ADDENDUM #1

Bronson Court Site Install HWT and Furnaces
8 Pages including this cover sheet

BID ADDENDUM NO. 1

Rochester Housing Authority
Bronson Court – Furnace and Hot Water Heater Replacement
2285-060

1 **DEMOLITION - TYPICAL 3 BEDROOM BASEMENT PLAN**
 1/8" = 1'-0"

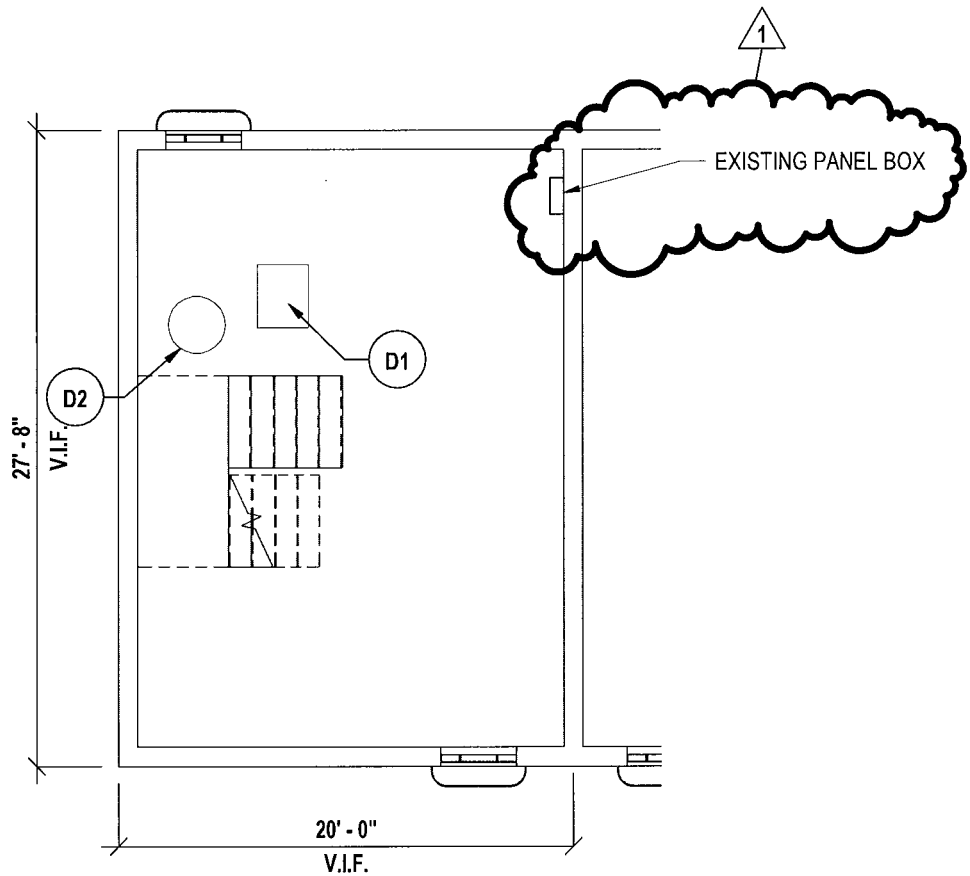
AMEND | Refer to M0.1-DEMOLITION – TYPICAL 3 BEDROOM BASEMENT PLAN
Existing panel box shown for clarity. |

1 DEMOLITION - TYPICAL 2 BEDROOM BASEMENT PLAN
 1/8" = 1'-0"

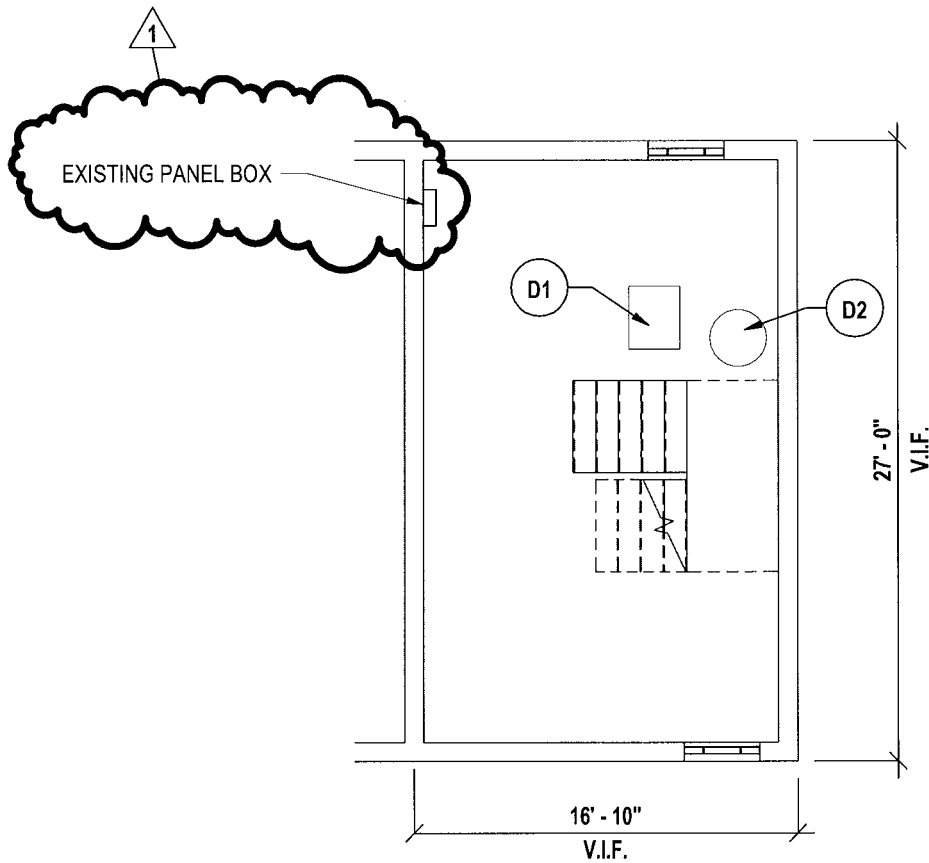
AMEND | Refer to M0.2-DEMOLITION – TYPICAL 2 BEDROOM BASEMENT PLAN
Existing panel box shown for clarity. |

1 NEW WORK - TYPICAL 3 BEDROOM BASEMENT PLAN
1/8" = 1'-0"

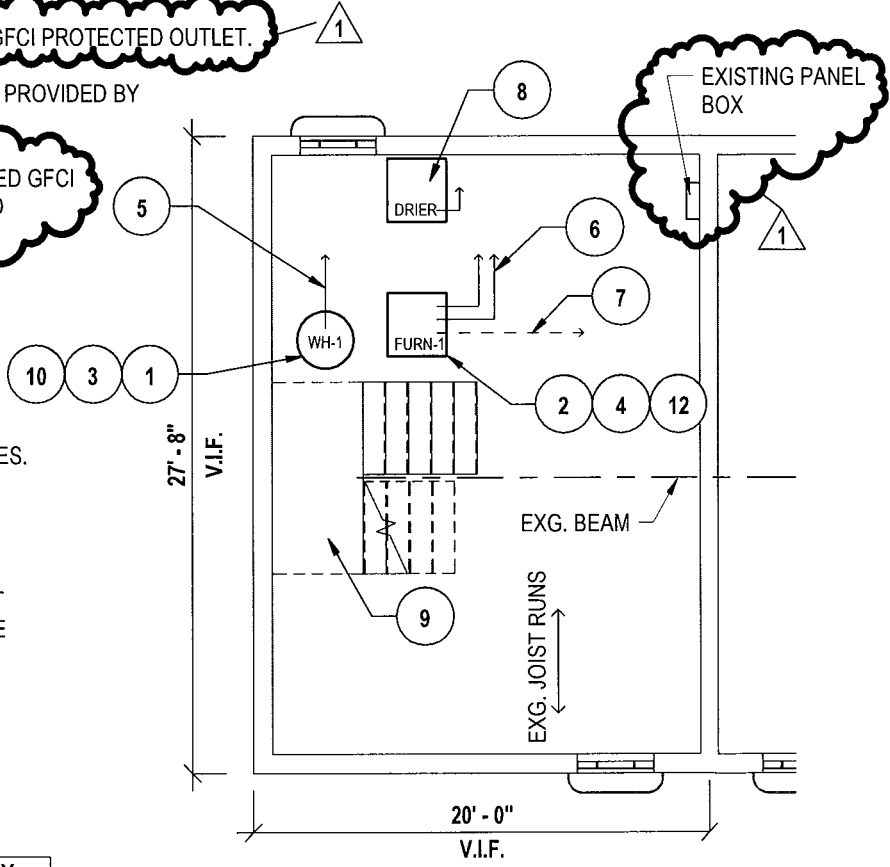
AMEND | Refer to M1.1-NEW WORK – TYPICAL 3 BEDROOM BASEMENT PLAN
Addition of Drawing Notes 10, 11, and 12 and existing panel box. |

10. CONNECT WH-1 TO NEW OWNER INSTALLED GFCI PROTECTED OUTLET.

11. NEWLY INSTALLED GFCI PROTECTED OUTLET PROVIDED BY RHA/ OWNER INSTALLED OVER WH-1.

12. PROVIDE INSTALLATION OF OWNER FURNISHED GFCI PROTECTED OUTLET/ SWITCH TO FURN-1 AND CONDENSATE PUMP.

1 NEW WORK - TYPICAL 2 BEDROOM BASEMENT PLAN
1/8" = 1'-0"

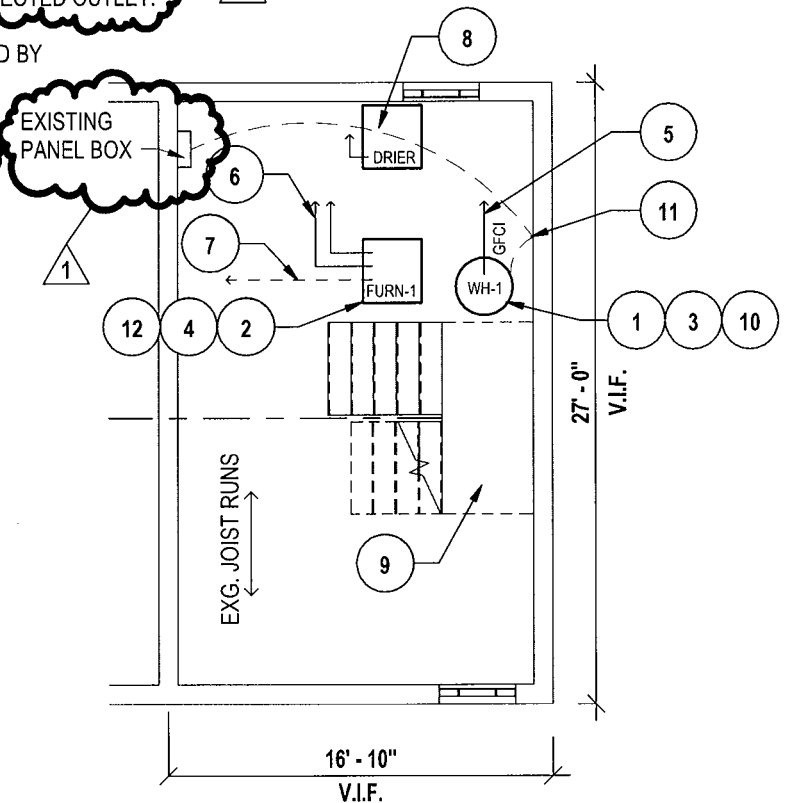
AMEND | Refer to M1.2-NEW WORK – TYPICAL 2 BEDROOM BASEMENT PLAN
Addition of Drawing Notes 10, 11, and 12 and existing panel box. |

10. CONNECT WH-1 TO NEW OWNER INSTALLED GFCI PROTECTED OUTLET.

11. NEWLY INSTALLED GFCI PROTECTED OUTLET PROVIDED BY RHA/ OWNER INSTALLED OVER WH-1.

12. PROVIDE INSTALLATION OF OWNER FURNISHED GFCI PROTECTED OUTLET/ SWITCH TO FURN-1 AND CONDENSATE PUMP.
